CHANGE HISTORY:

Title: CALCPACK HP 82001

Size: A4	Date: 2024-09-24	**Rev: 4.0**
KiCad E.D.A. 8.0.5		Id: 1/1

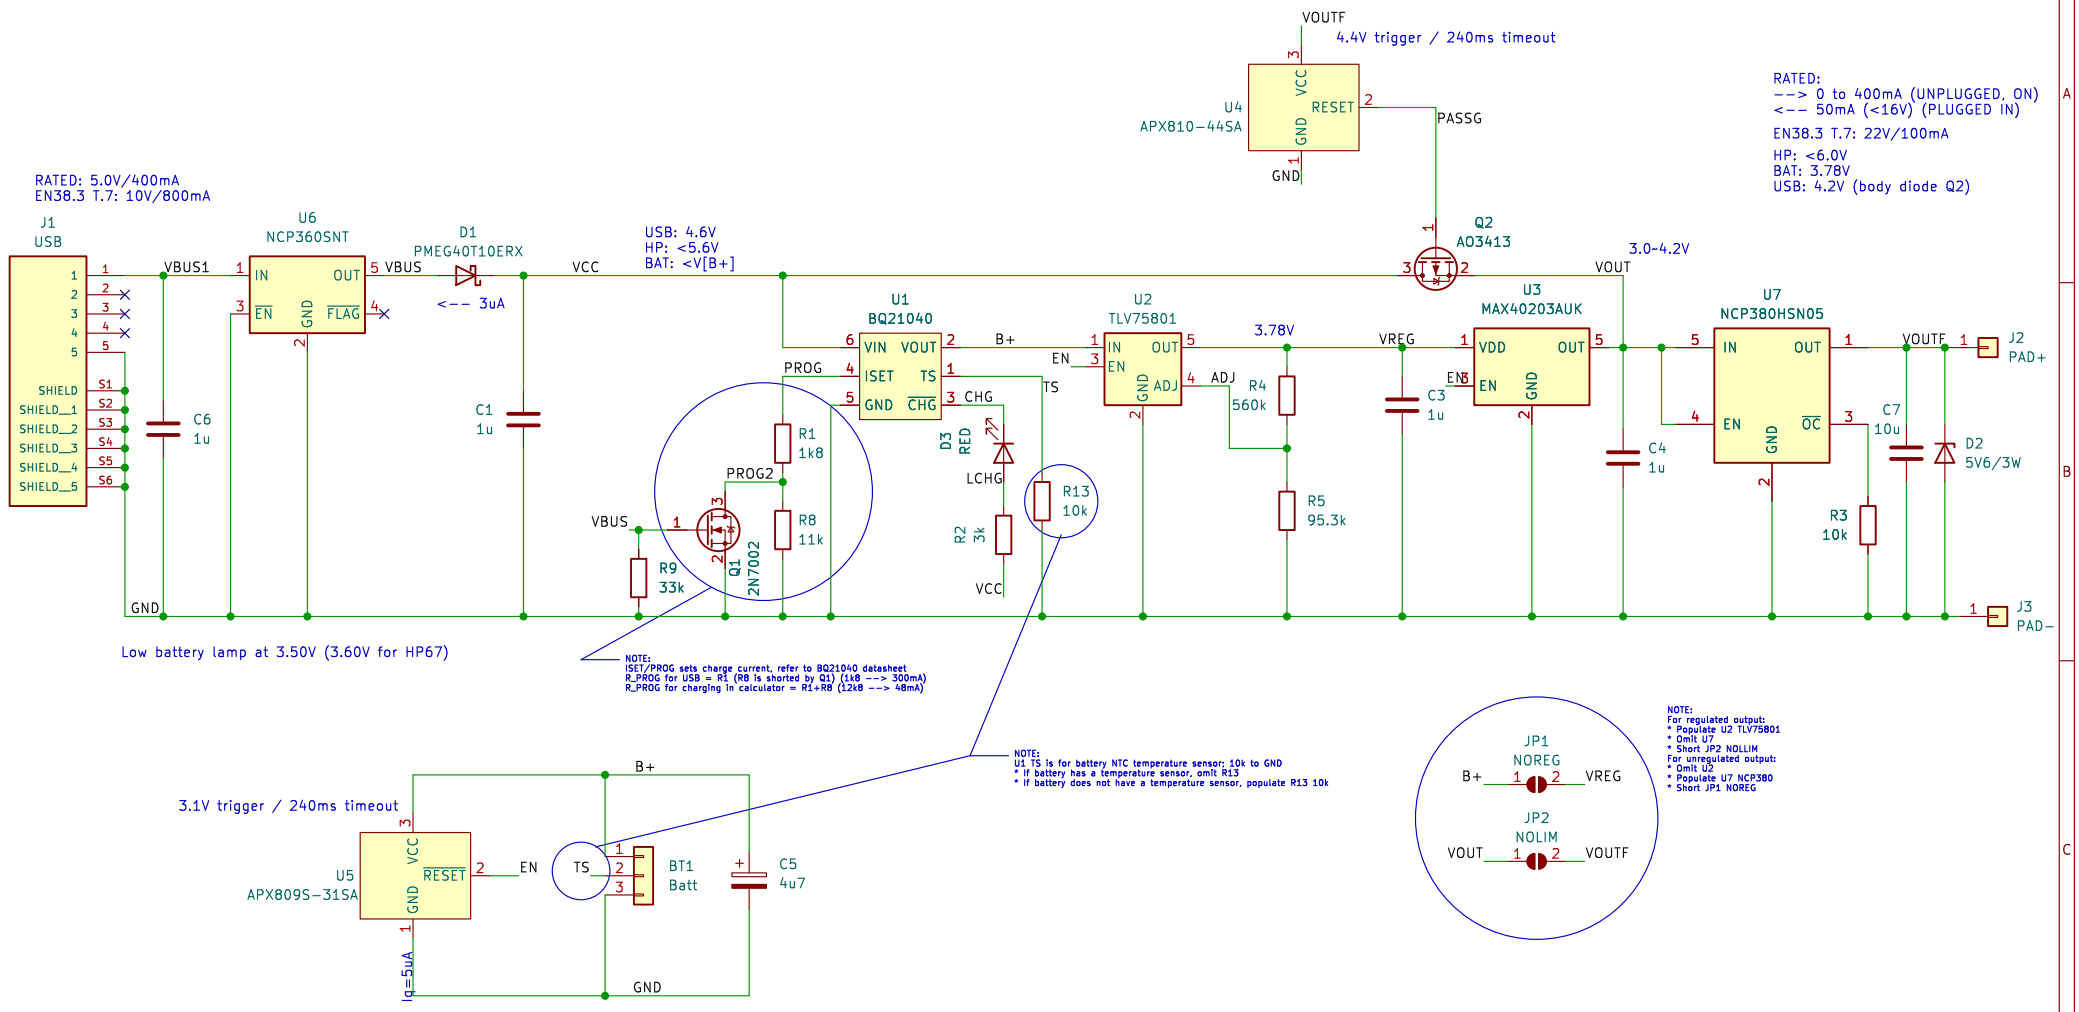
REV1 ADD Q1,R8,R9

REV1.1 U2=TPS73101, U4=S-8261ABJMD, R4=300k, R5=160k, update notes

REV1.2 change D1 to 1N5817, change D2 to 5V6, R8=24k, Add C6

REV2 BOARD LAYOUT CHANGE

REV3 ADD U6, C6, F1. change U4 to TPS3808 (+C4,R6,R7,R10,R11), change U1 to BQ21040, add Q2,D7,R13, move C2, add C7, new name

REV 3.1 remove F1, change R5 to 95.3k

REV 3.2 change U5 to APX

REV 3.3 Add U4,Q2 for active backfeed

REV 3.4 Change R1 to 1k8, R8 to 11k, C7 to 10u

REV 3.5 Add U7, C4, JP1, JP2, move U4 pin3 to VOUTF, del C2

REV 4.0 JP1 B+ to VREG. Layout changes.
